# URGENT MEDICAL DEVICE CORRECTION

October 20, 2022

**Problem Description** Baxter Corporation is issuing an Urgent Medical Device Correction to the user level for the Novum IQ Large Volume Pump (LVP). This correction is related to two different software issues that occur during use. These issues apply to both currently marketed software versions 1.1.3 and 1.1.4 unless otherwise noted below. The issues do not occur for infusions run to completion.

Figure 1: Expected and Unexpected Screen Transition During the 'Air Still Detected' Alarm Workflow

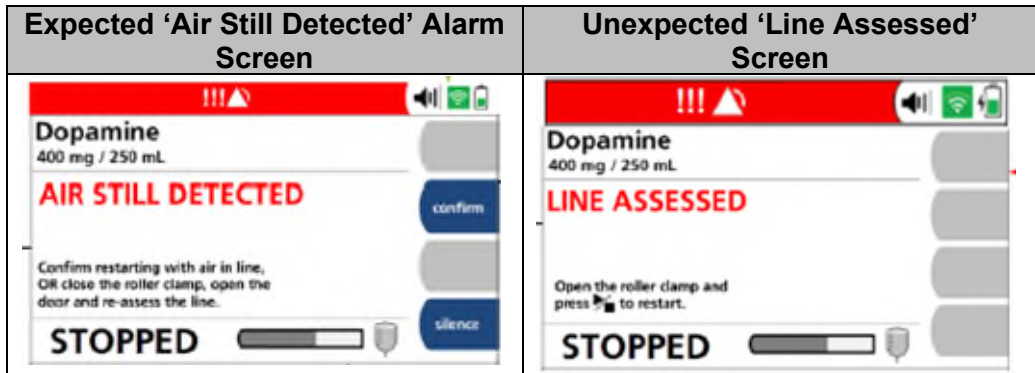
The second issue observed is an unexpected screen transition during the 'Air Still Detected' Alarm workflow. The issue occurs when the user is resolving a high priority 'AIR IN LINE' alarm, elects to continue the infusion and does not clear the air in line. The issue results in cases where the 'Air still Detected' alarm does not occur.

Instead, the pump transitions directly to the 'Line Assessed' screen with high priority alarm visual indicators i.e., alarm banner on display and red flashing beacon light.

These alarm visual indicators (alarm banner and red flashing beacon) persist for the remainder of the infusion and do not clear until the user opens the door. While these alarm visual indicators are present, any alarms of relatively lower priority than the “Air Still Detected” alarm are not presented to the user i.e. displayed or accompanied with an audible alarm such as Upstream or Downstream occlusion alarms. See the Operator’s Manual, Table 8-2 General Alarms for the complete list of alarm prioritization.

Figure 2: Unexpected KVO Screen

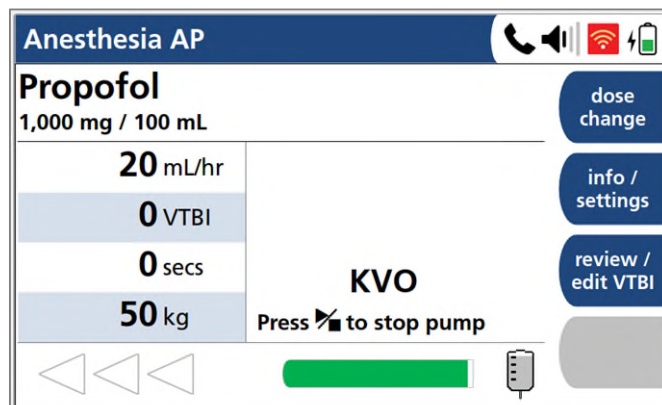
Monitor the patient during bolus delivery to completion or minimally at completion to ensure appropriate return to the maintenance rate. Upon completion of the bolus if a premature transition to KVO occurs (See Figure 2).

- Press the 'run/stop' key to stop the infusion
- Select 'review / edit VTBI' soft key
- Select 'edit program'
- Reprogram the VTBI
- Press the 'run/stop' key to resume the infusion
